May 2023 | Final Environmental Impact Report
State Clearinghouse No. 2023010230

MCKINLEY ELEMENTARY SCHOOL CAMPUS MASTER PLAN PROJECT

for Santa Monica-Malibu Unified School District

This section provides all written responses received on the DEIR and SMMUSD's responses to each comment.

Figure 3-7c - Proposed Project Site Plan - Phase 3

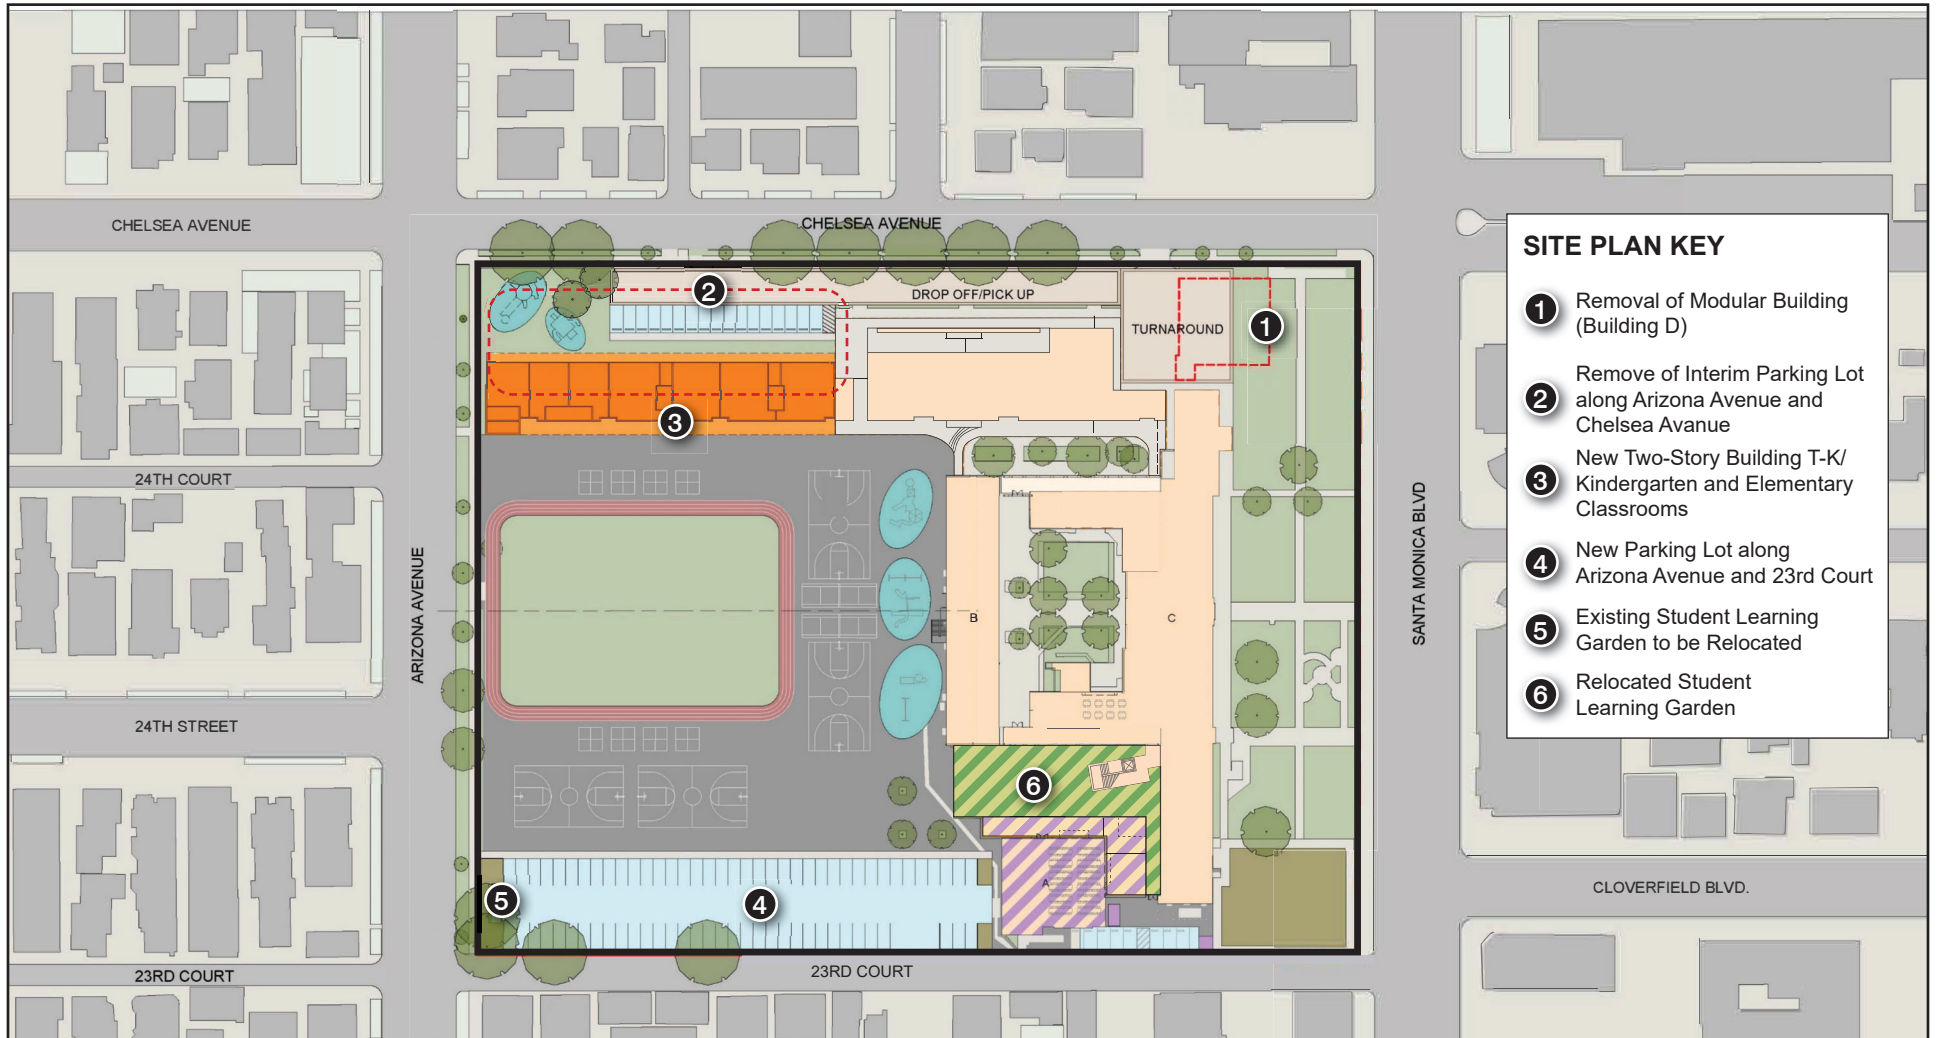
<p>6. Figure 3-7c Phase 3 (4) references only "new parking lot along Arizona Avenue and 23rd Court." There is ZERO REFERENCE to the destruction of the decades old, mature, award-winning McKinley Student Learning Garden. There are NO PHOTOS in the entire plan of the existing Garden.</p>	<p>R5-10</p>

R5-10 This comment states that Figure 3-7c, *Proposed Project's Site Plan: Phase 3*, does not reference the location of the existing student learning garden.

In response to this comment, Figure 3-7c, *Proposed Project's Site Plan: Phase 3*, has been revised to identify the location of the existing student learning garden and location of the new student learning garden, adjacent to the cafeteria (Building A). The proposed figure revision does not require recirculation of the EIR because it does not provide significant new information that would give rise to a new significant environmental impact; a substantial increase in the severity of an environmental impact; or suggest a Project alternative or Mitigation.
